SITE EVALUATION REPORT

PIN NUMBER: 1725863843 "D" PERMIT #: WREP-074869-2022			
OWNER/APPLICANT: Millie Wilder			
SUBDIVISION: Montague LOT NUMBER: 6			
LOCATION OF SITE: 4121 Jane Lane			
FACTORS	AREA 1	AREA 2	AREA 3

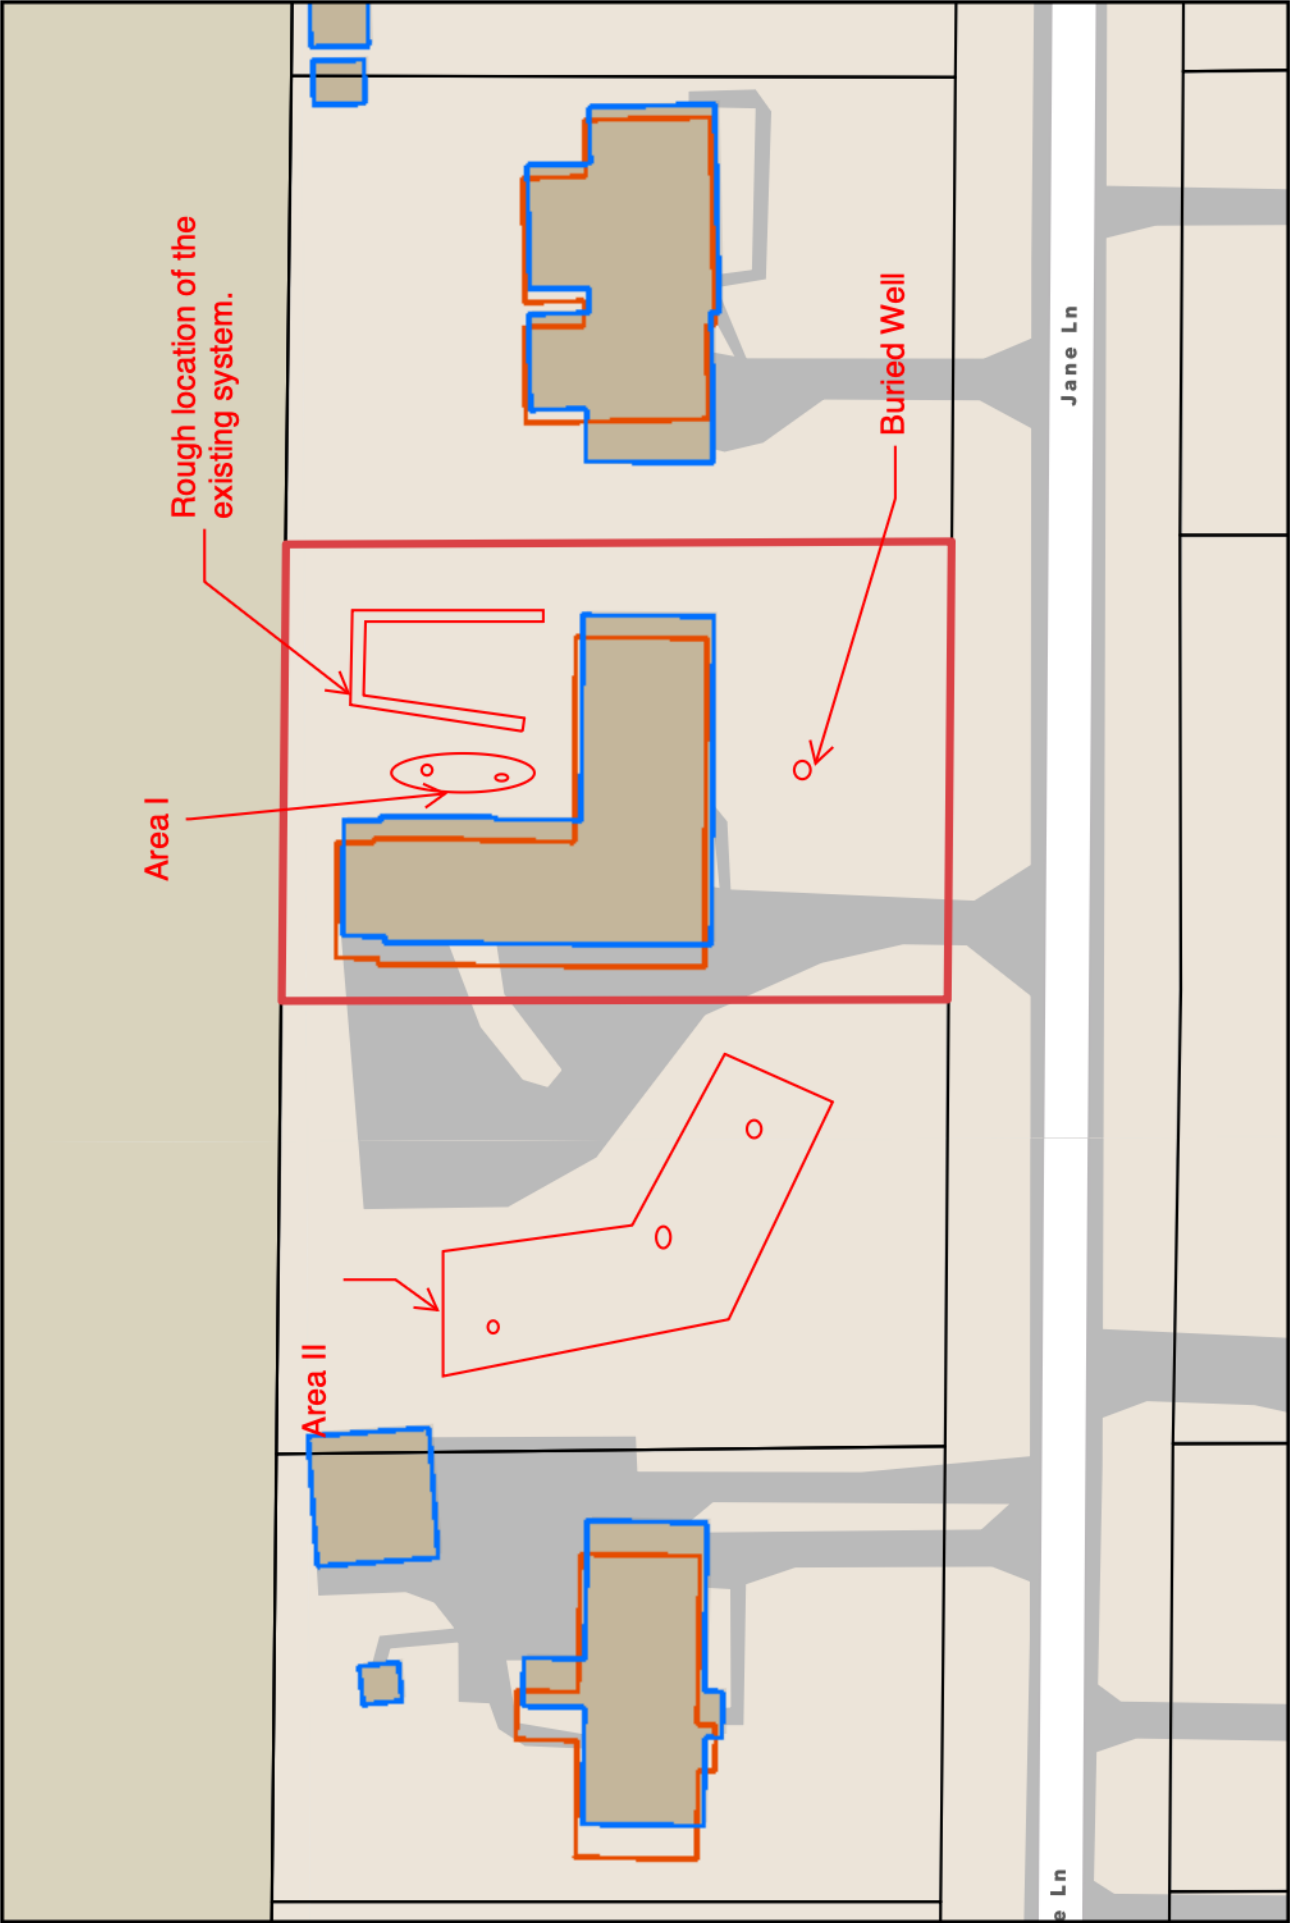
14. Available Space: Yes ☐ No ☒			
15. Site Classification: <u>Area I Unsuitable due to lack of available space. Lot can be re-classified as Provisionally suitable for a reduced size drain field to provide some relief.</u> <u>Area II is on the adjacent lot and needs to be further investigated in pits. g</u>
